# Metropolitan Development Commission Plat Committee (September 11, 2024) Meeting Agenda

**Date:** Wednesday, September 11, 2024    **Time:** 1:00 PM

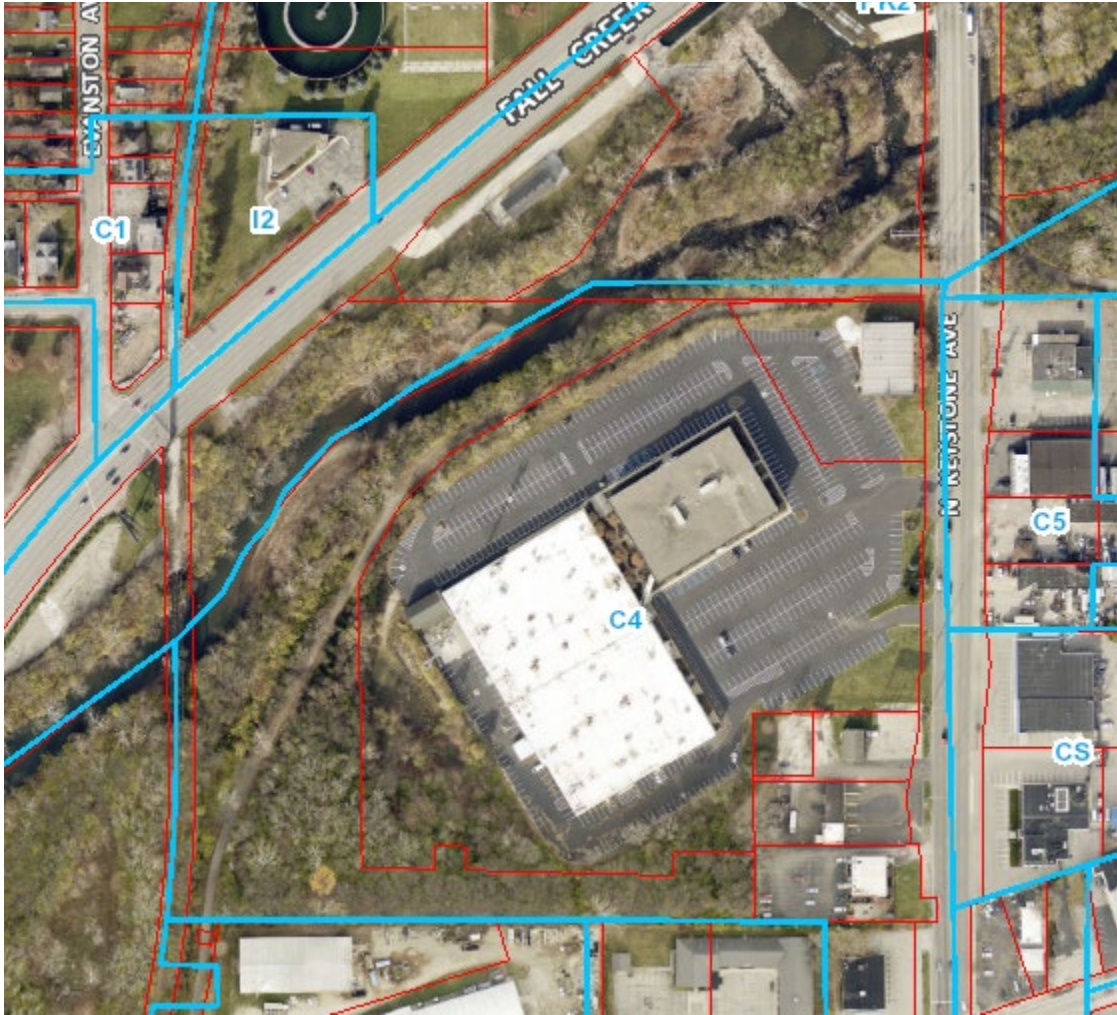
An easement exists along the north end of the site for the Fall Creek Greenway which shall remain in place as a part of the proposed plat.

2024-PLT-057 ; Primary Plat

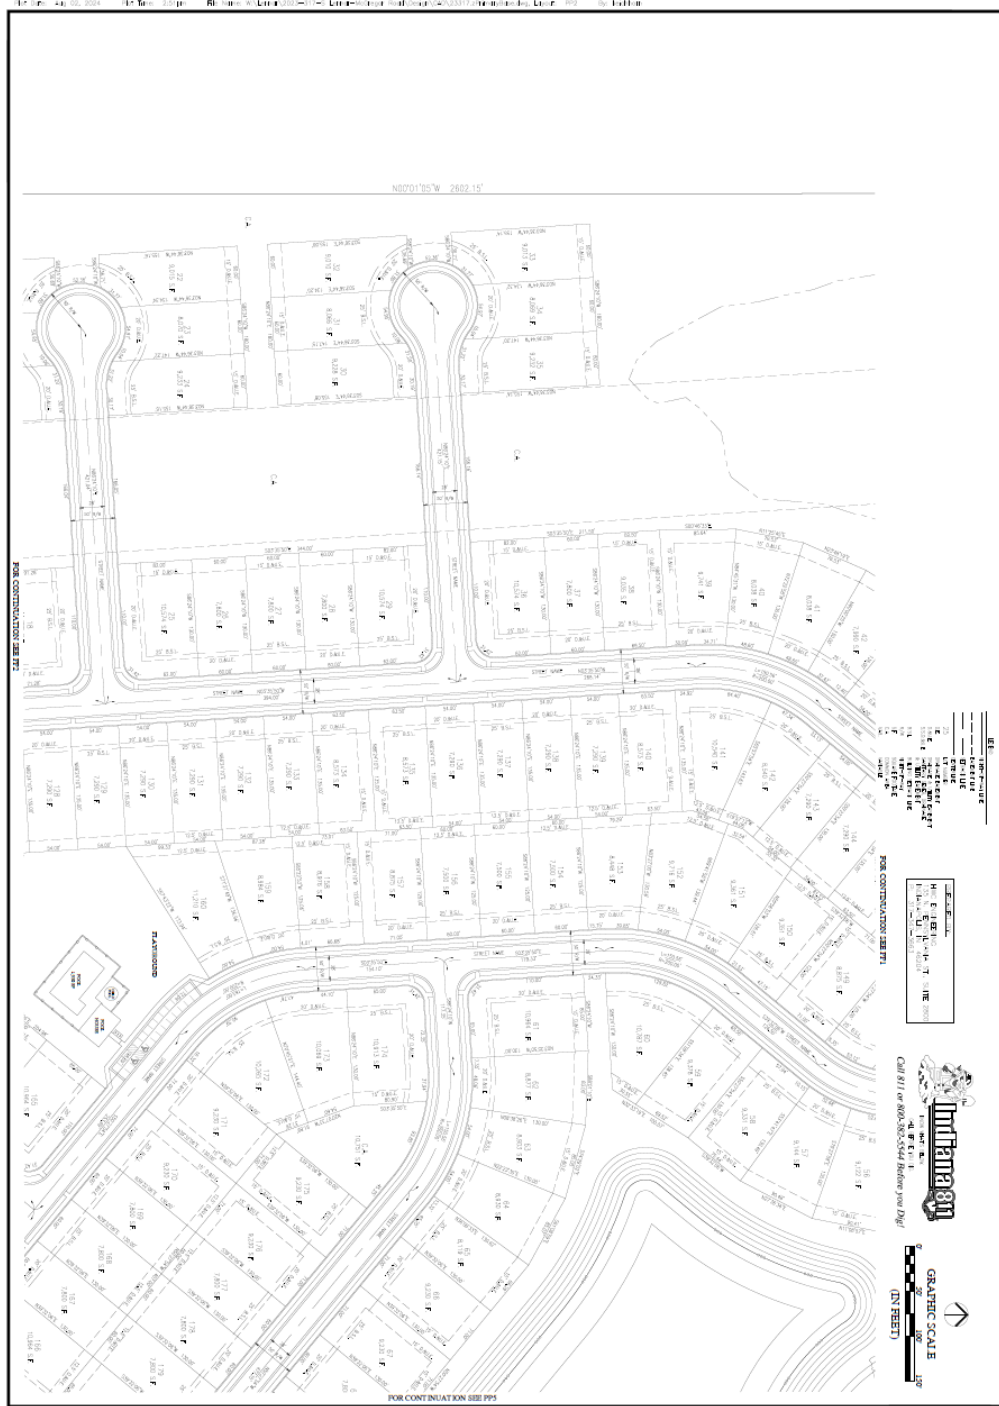
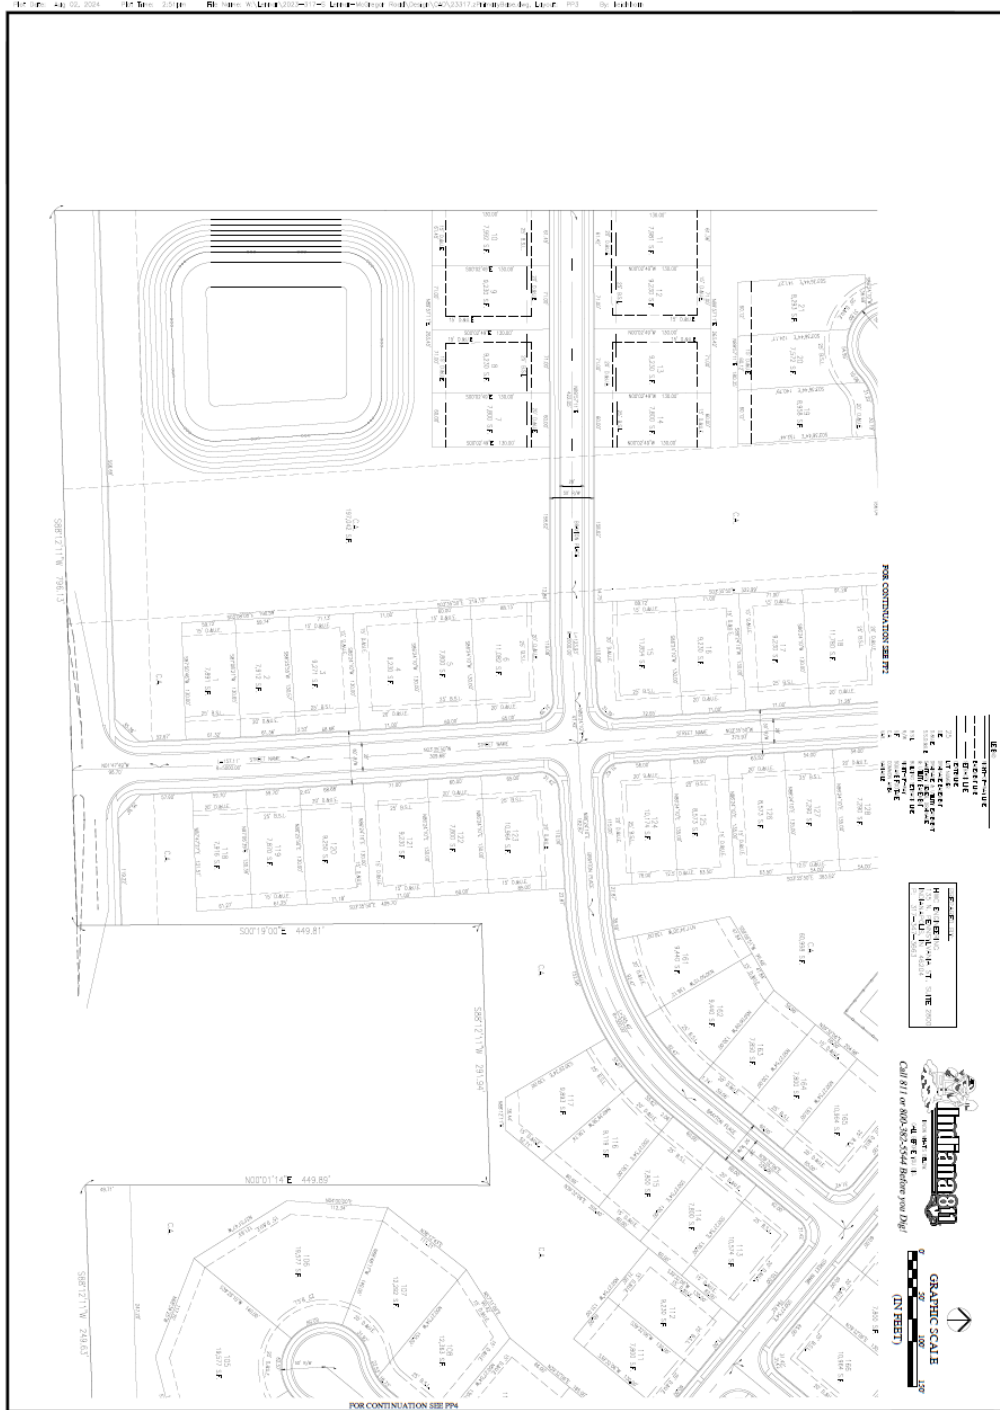
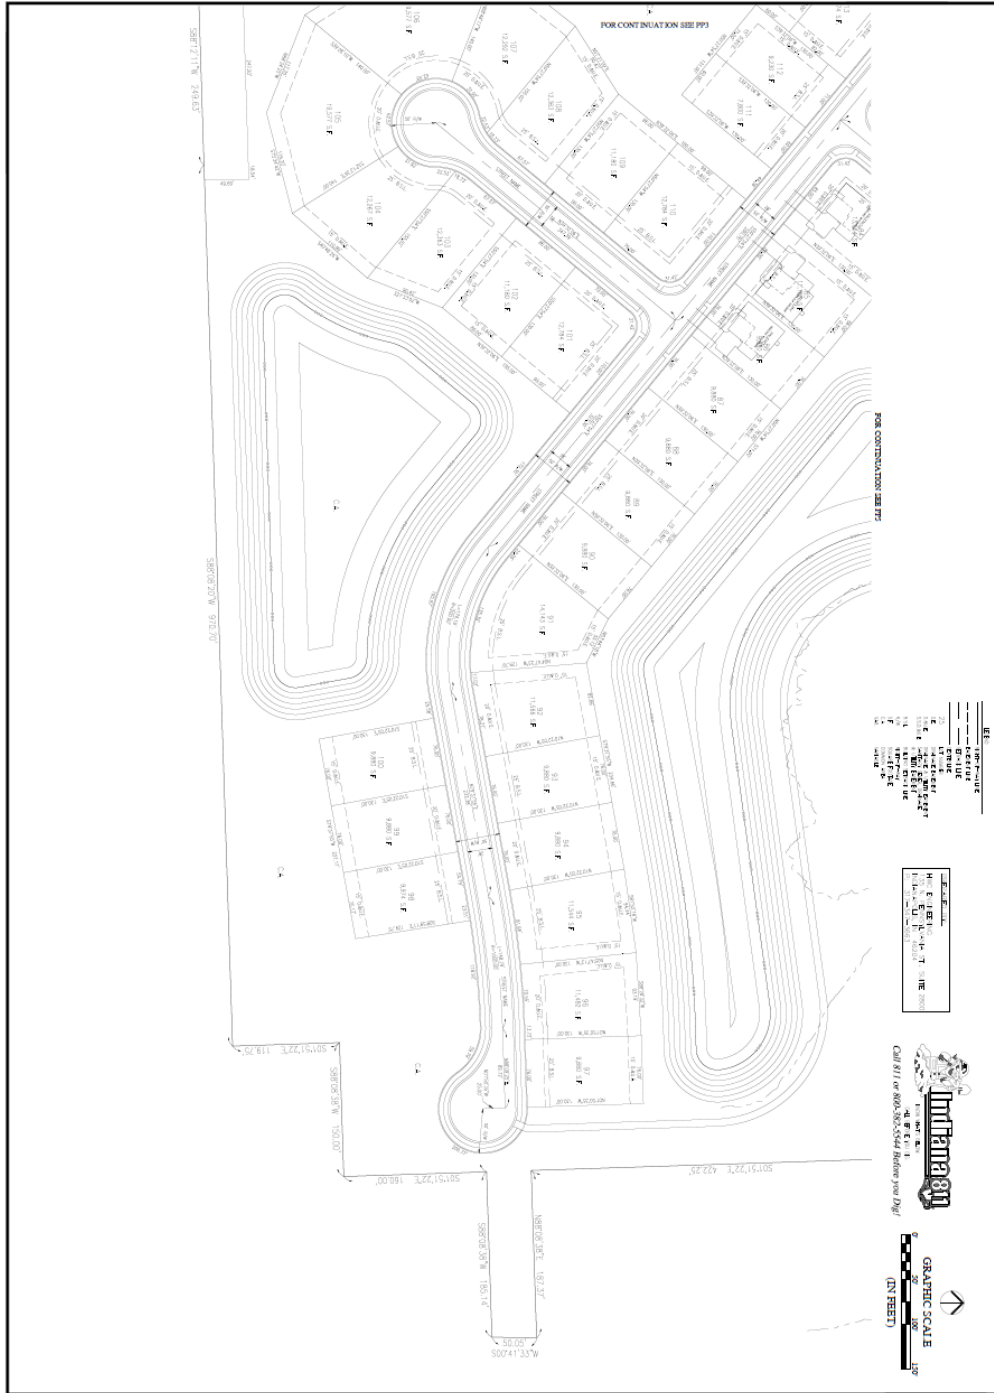
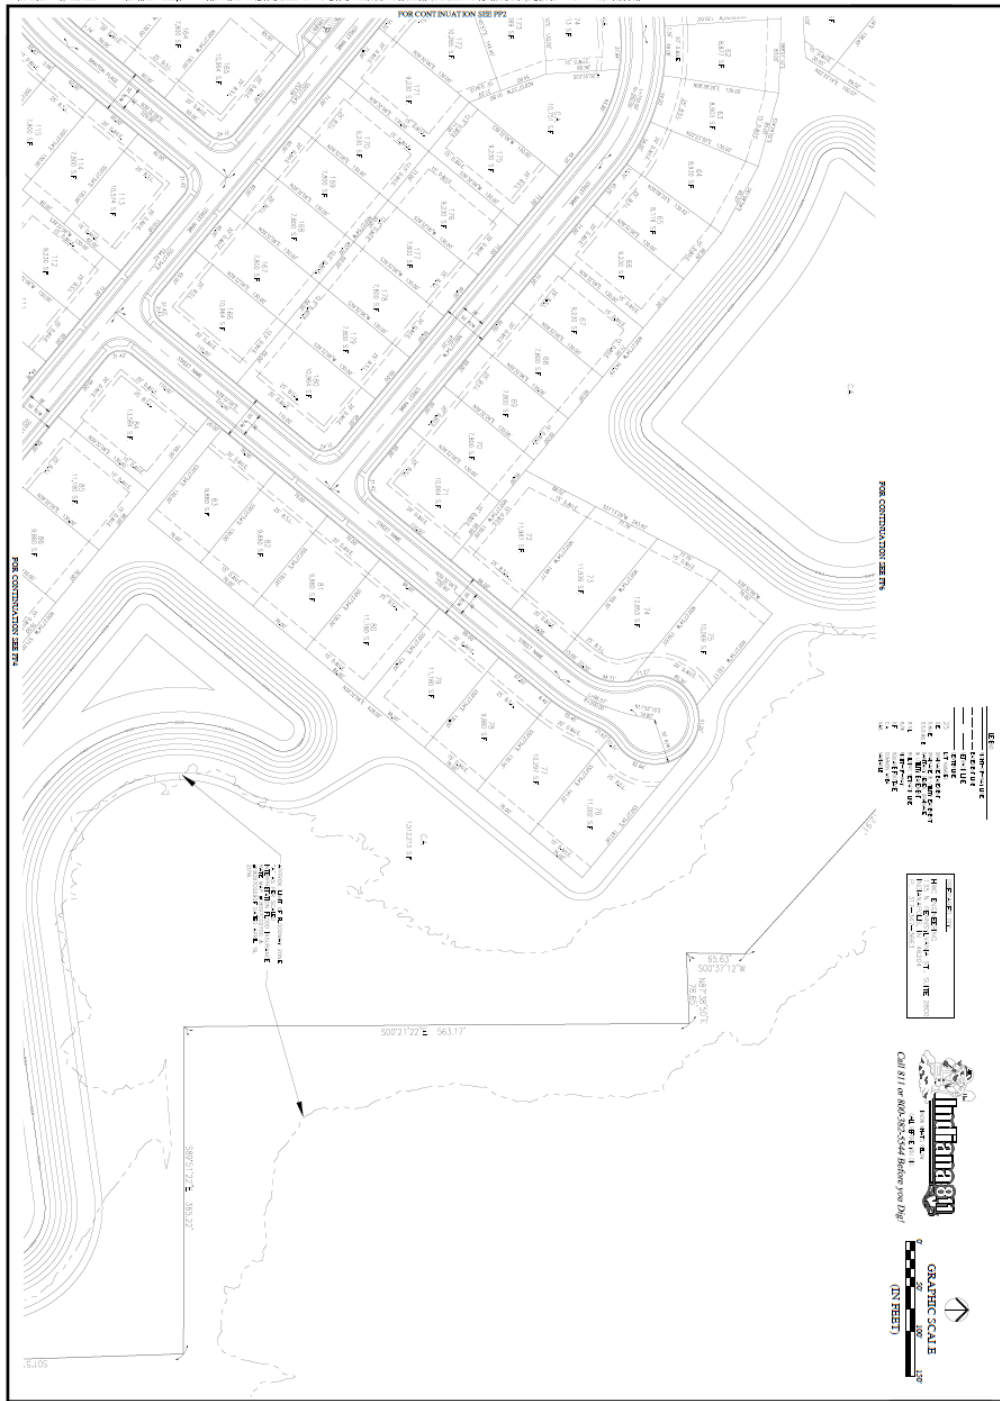
12. That the requested waiver of maximum 500-foot length of the cul-de-sac requirement, per Chapter 741, Article III, Section 3.D of the Consolidated Zoning and Subdivision Ordinance, be approved on the condition that the 15-foot-wide pedestrian access/public utility easement required by 741-303 be affixed to the final plat prior to recording.

13. That required sidewalks along Hickory Road and the portions of the plat with frontage along McGregor Road be affixed to the final plat prior to recording.

The plat would provide for seven new streets in addition to the extension of Brayton Place from the development to the west: two local streets and five cul-de-sacs. One new street would roughly run north-south and would connect Southport Road with McGregor Road, and the other would solely serve to connect the site internally. Each proposed cul-de-sac would have a compliant length except for the one to the far southeast of the site which would span a length of 980 feet. Despite this, it would only service 15 lots (less than the maximum of 20 indicated by ordinance). This, coupled with the fact that no feasible access points to McGregor or Hickory Road exist due to existing residential development, would cause staff to recommend approval of the cul-de-sac waiver request if the required 15-foot pedestrian access/public utility easement were added to plan to provide connection between the cul-de-sac head and Hickory Street to the east.

Sidewalks are required along Southport Road, McGregor Road, Hickory Road, and all proposed interior streets. A condition has been added to ensure that required sidewalk would be shown on the plat along the southeastern portion fronting on McGregor and along Hickory prior to final recording.
